Project: 23-10 - Travers Park Reno: Phase 1
2016 Pine Street
Sandpoint, Idaho 83864

Prime Contract Change Order #011: Safety Fence, Credit:Bike Rack, Seed & Boulders

Prime Contract Potential Change Order #052: CE #107 - Safety Fence

1 FLOOR PLAN - PICKLEBALL COURT DIMENSIONS
SCALE: 3/32" = 1'-0"

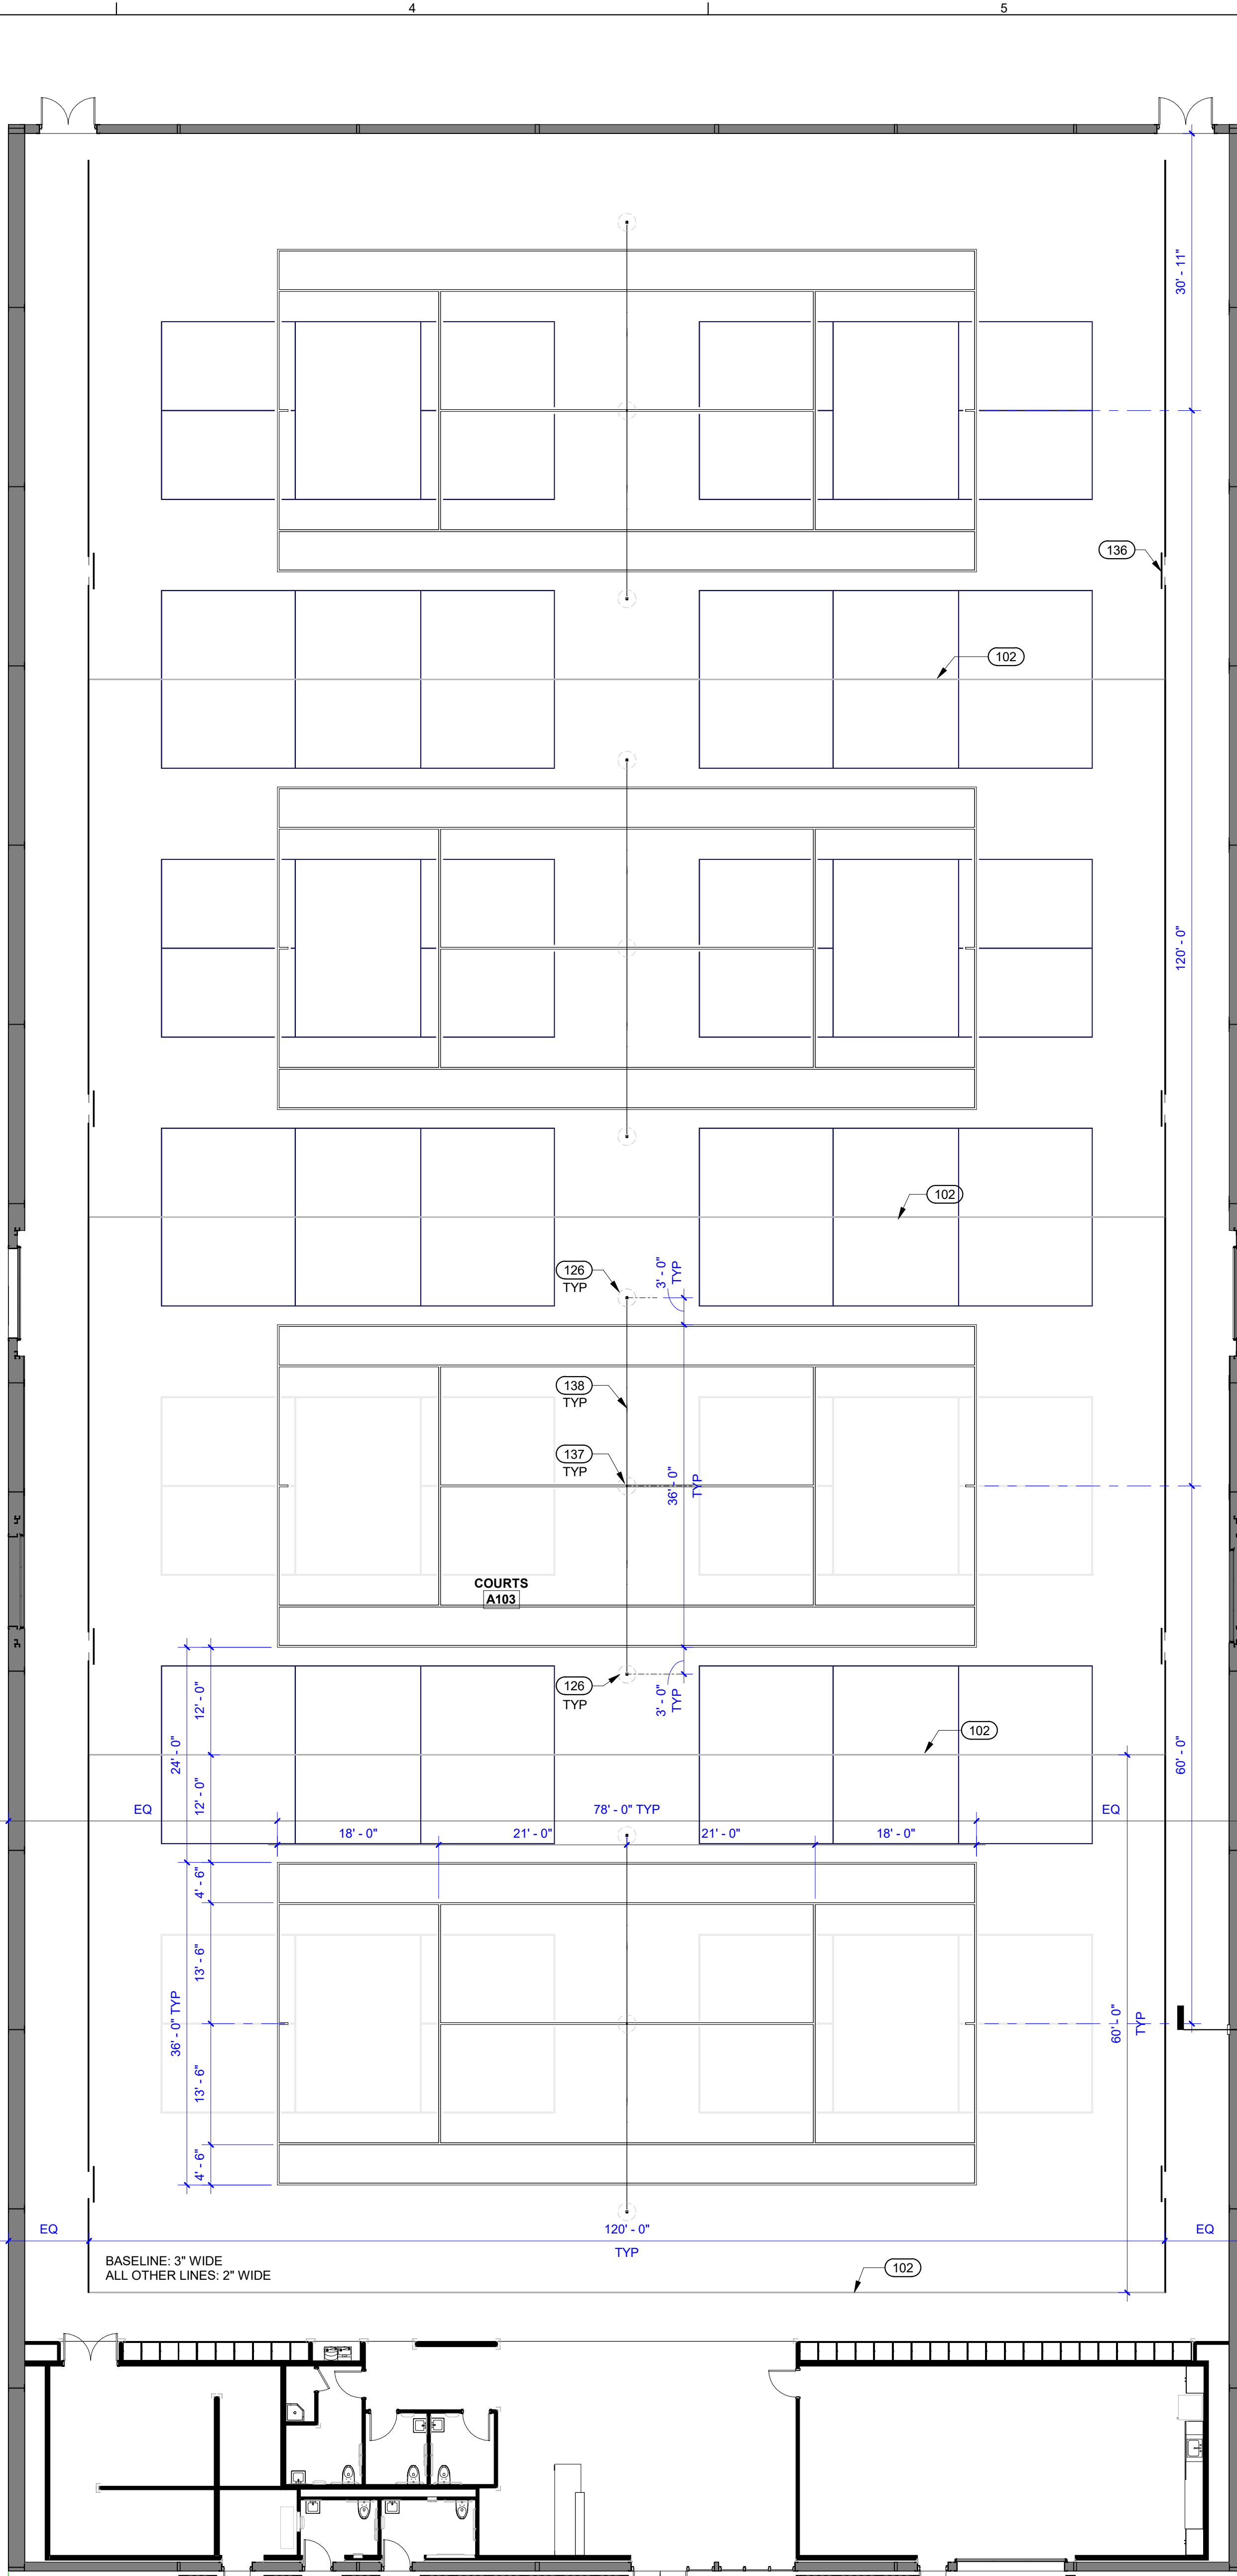
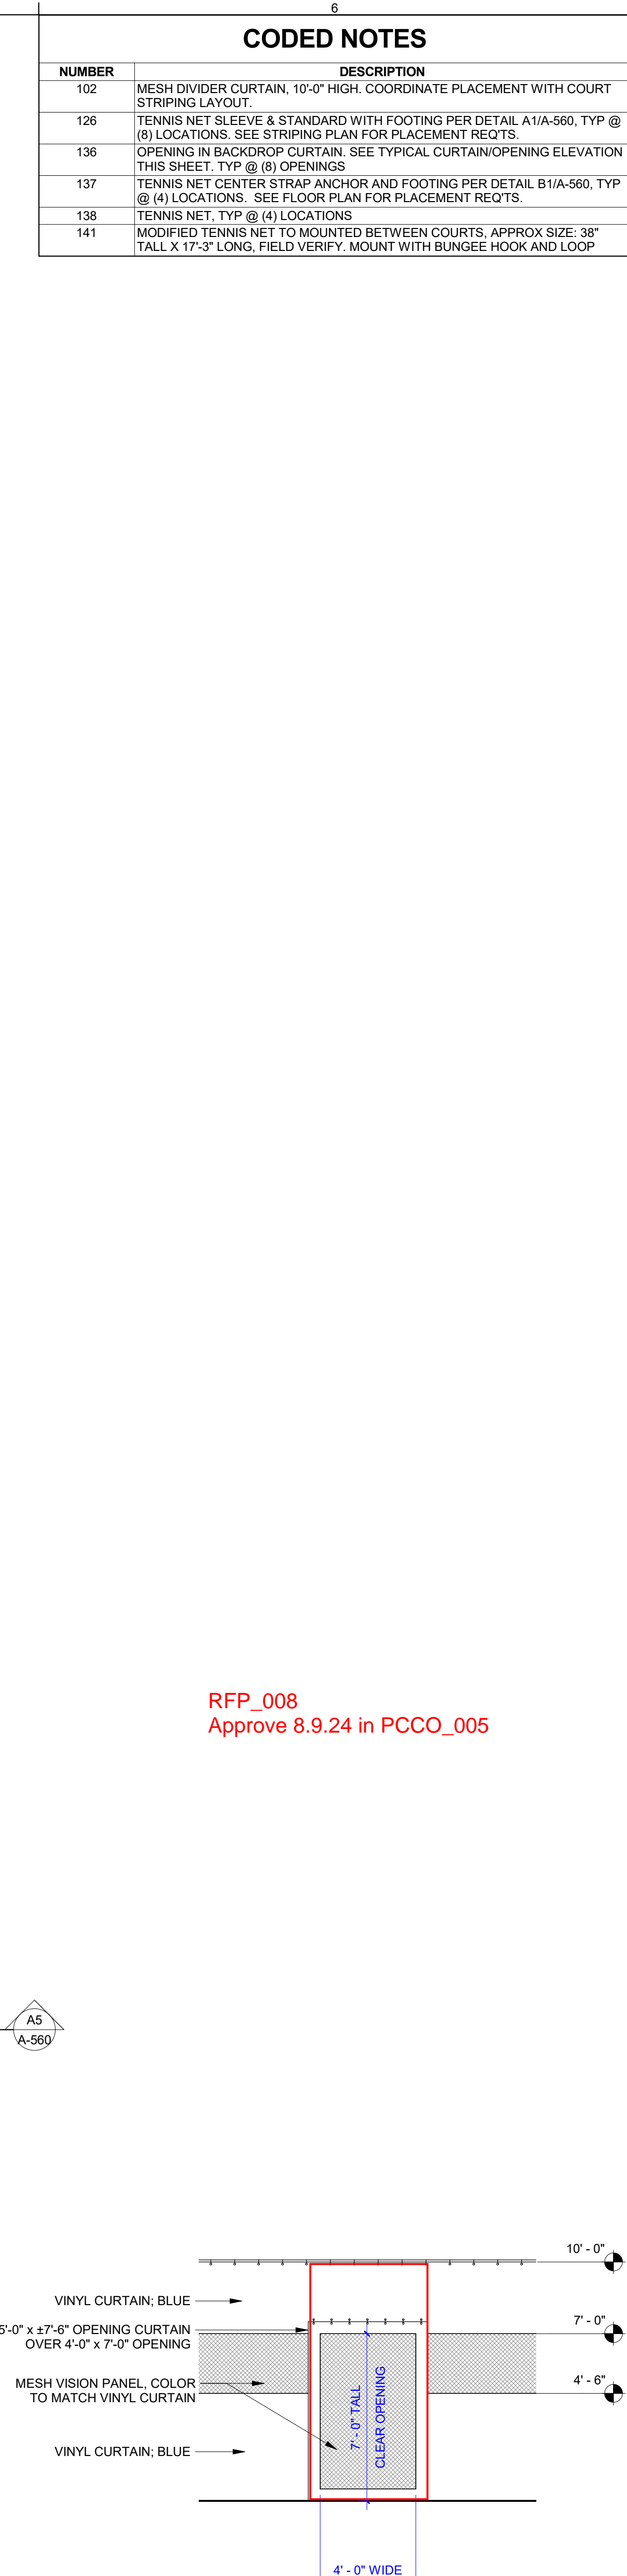
- Back drop curtains, N/S Curtains:
 - Eliminate California corners as shown on attached sheet.
 - Vinyl curtains to be blue to match "Light blue" court color. Provide color samples to make selection.

- Add 3'-6" x 7'-0" openings centered on south sideline of each tennis court. Provide a vinyl net "door" at opening; to be made of the same material as the vision panel described below. Overlap at 3" minimum at sides of opening. See revised plan attached.

- Add vision panel continuously along backdrop vinyl curtains from 4'-6" AFF to 7'-0" AFF (align with top of opening. Mesh material to be vinyl coated polyester 11x11 mesh, or similar, minimizing visual access from tennis court to walking aisle. Color to match curtain; provide color samples for selection.

- Provide 8'-0" minimum wide section of back drop curtain to be drawn allowing movement of pickleball nets in and out of court areas.
 - Provide pricing for pulley (Split Bracket Pulley, 1 3/8").

- Provide pricing for SS cable & Steel Carabiner.
- Divider Nets; E/W Nets:
 - Provide 13'-0" tall nets, attached to the cable to east and west walls @ 13'-0" AFF. Provide vertical cable supporting the tensioned cable at center.

- Provide pricing stainless steel cable and aluminum carabiners.
 - Provide pricing to add Split Bracket Pulleys, 1 3/8".
 - Provide chain at bottom pocket of divider nets. Chain at bottom of divider nets to sit on ground.
